The Committee of 100  
on the Federal City

| March 1<sup>56</sup>, 2017

Subject: Comments on Anacostia Park Management Plan Environmental Assessment

Figure 1. Anacostia Management Plan Alternative 3 (preferred alternative)

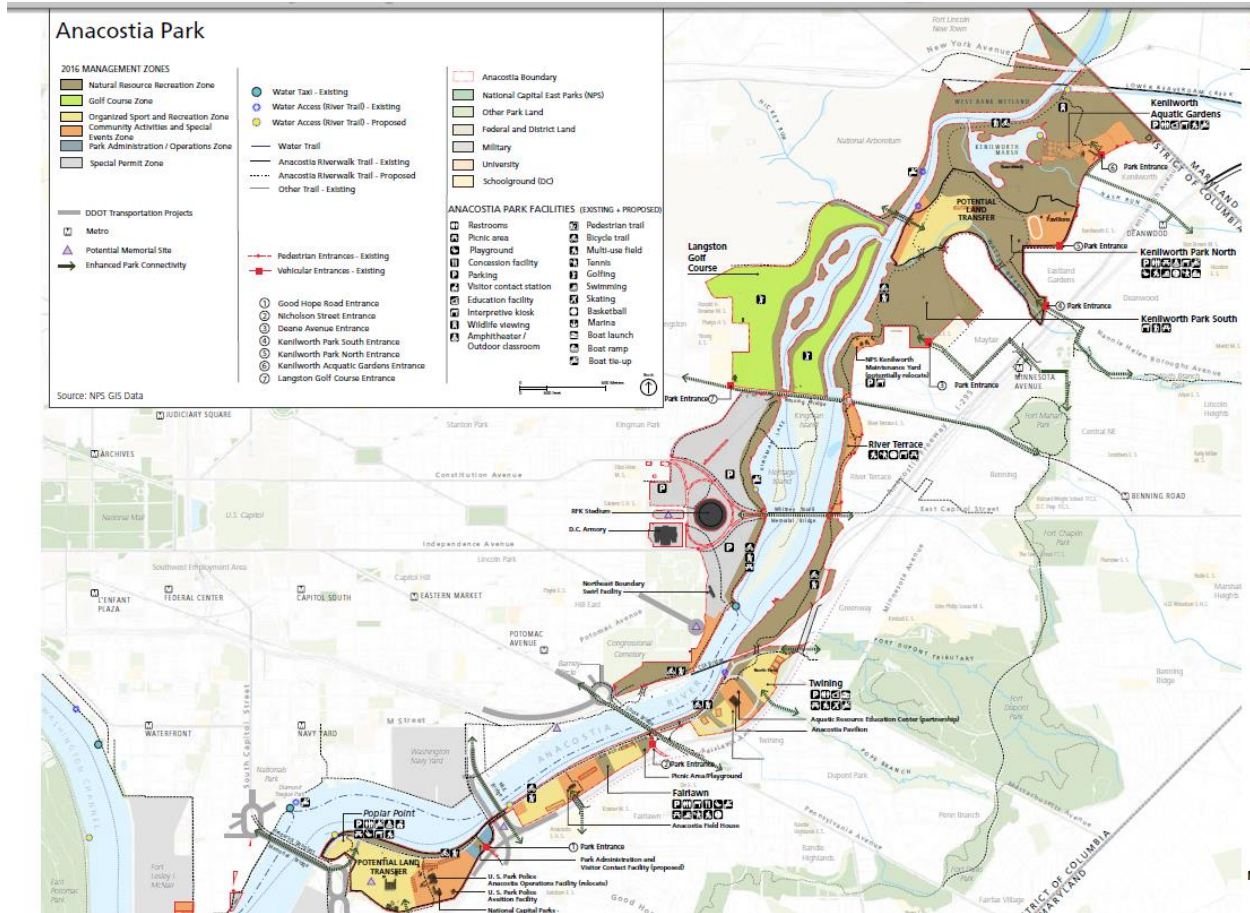
It appears that this proposed Management Plan, as is the case with many government reports, was some time in development and thus it does not contain references to the recent reports on climate change from DOEE.<sup>6</sup> The map in Figure 1 offers a lot of information, perhaps too much, confusing trail routes with future flood plains. The limits of the 100- and 500-year flood plains are unclear because graphics similar to what is used for Trails are used to depict the flood plains. A clear graphic depiction of flood plains does not appear until Figure 15 (page 105 of the EA).<sup>7</sup>

Figure 2B. DC Department of Transportation's proposed Park Drive, DDOT, "Middle Anacostia Crossings Study," p. 7-47 (2005).

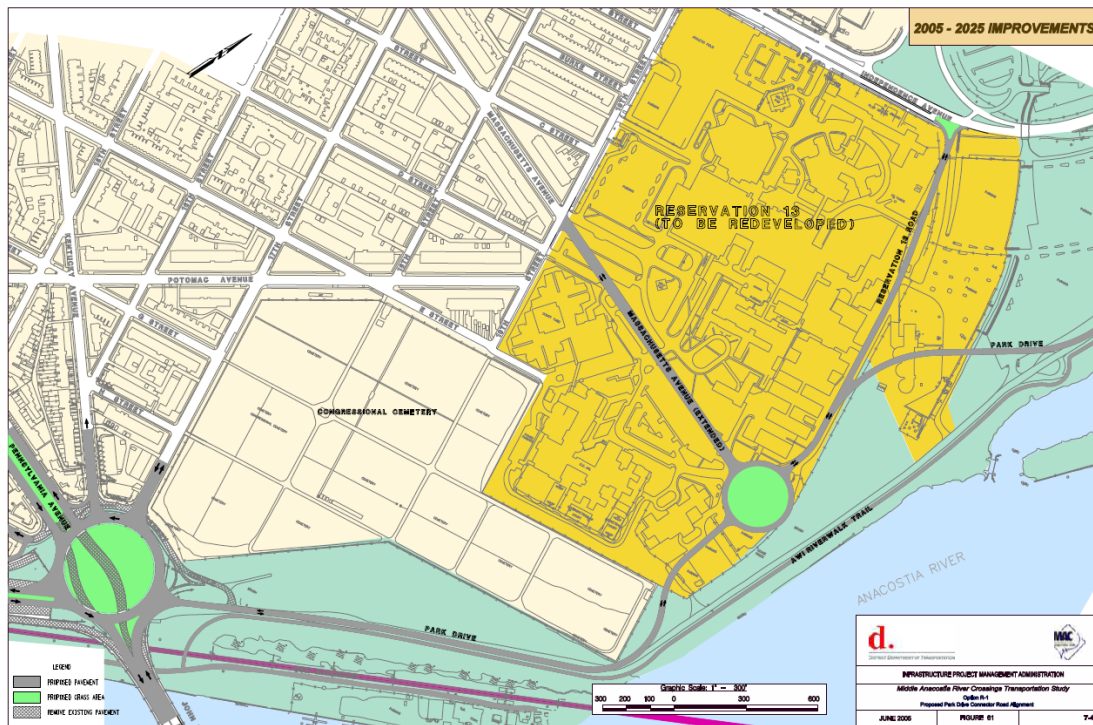
Although Alternative 3 would allow new visitor access points, including roads, trails, and park entrances, we urge that the Management Plan limit any road building to these uses. In contrast, DDOT and EventsDC are planning a new road through Anacostia Park along the west bank of the river through natural resource areas adjacent to RFK Stadium and Congressional Cemetery. Figures 2A and 2B. DDOT's "Park Drive" would be a commuter road from Benning Bridge to Barney Circle. Roads threaten wildlife.<sup>3</sup> Additionally, the Anacostia Riverwalk Trail offers many health and education benefits. This road would have a direct and negative impact on the natural resources areas, the Anacostia Riverwalk Trail, and block access to the river. The CSX tracks already intrude into this area, and a new road would further threaten wildlife, pedestrians, and cyclists, the intended beneficiaries of the Management Plan. In addition, almost all this area is within the 100-year floodplain. Management Plan (Figure 15). This road is not essential and should not be built; developers do not need it to access Reservation 13 (HillEast Waterfront/DC General site). Residents of eastern Capitol Hill have repeatedly objected to the "Park Drive" in public meetings.

Figure 3. Active CSX rail lines in the District of Columbia. Source: CSX EIS application, Virginia Avenue Tunnel.

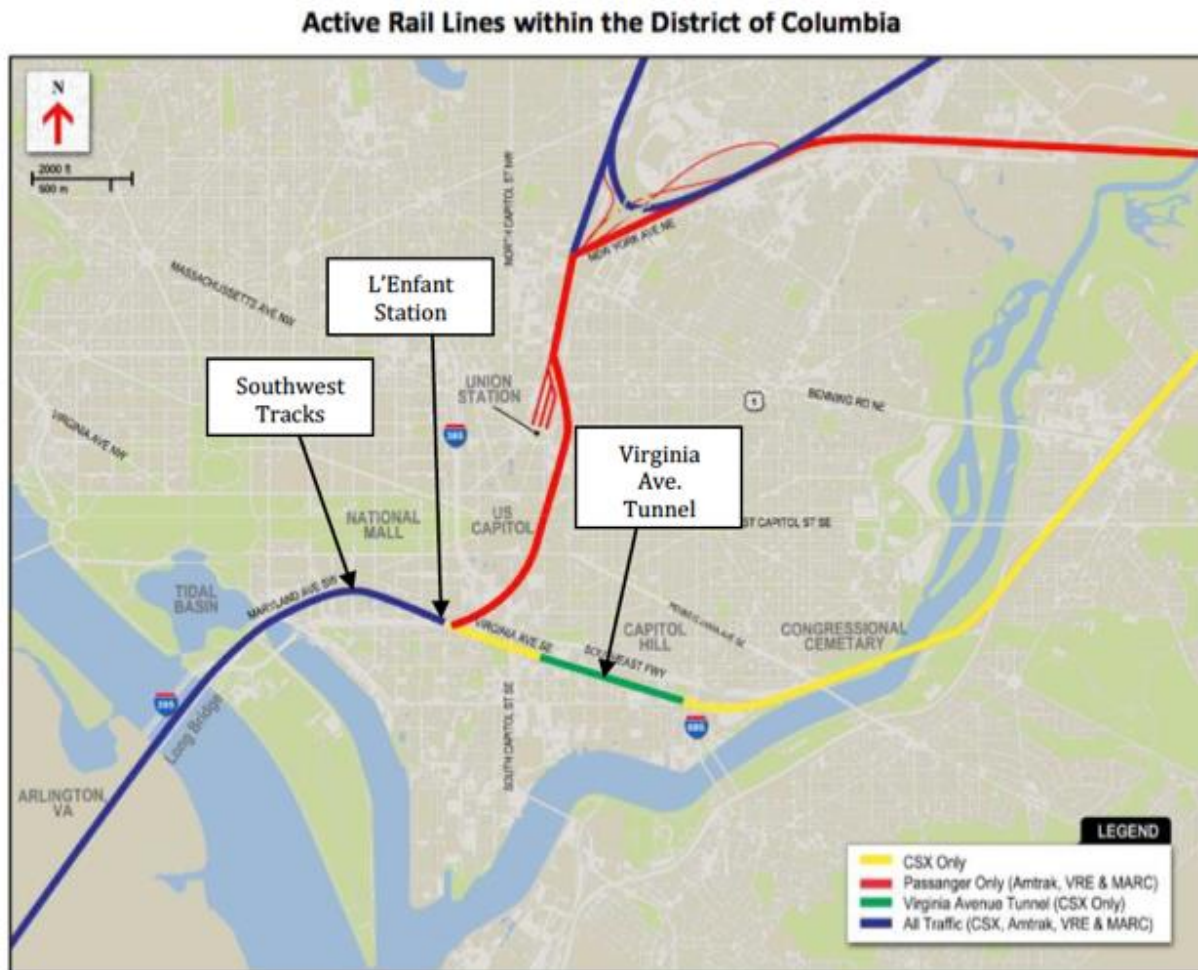
Detailed maps are essential for successful planning. To achieve the goals of the Management Plan, the map of the park should show the CSX rail lines running through the park on the east and west banks of the river (see Figure 3). On the east side of the river, the tracks divide Anacostia Park, go under Route 295, and branch into seven tracks that comprise the Benning

CSX plans to increase the number of trains; many will be double-stacked. In addition, CSX uses a rail bridge, the Benning Bridge (not shown in Figure 3). Please see photograph of CSX train traversing the CSX Anacostia Bridge (Figure 4.) This bridge, with its low clearance, is already subject to flooding, and blocks navigation above the bridge (except for very small boats, such as canoes).<sup>5</sup> It will need to be replaced, and the Management Plan should specify the location and height specifications for a new bridge in order to improve resilience and provide the opportunity for all boaters to use the river north of the current CSX Anacostia Bridge.
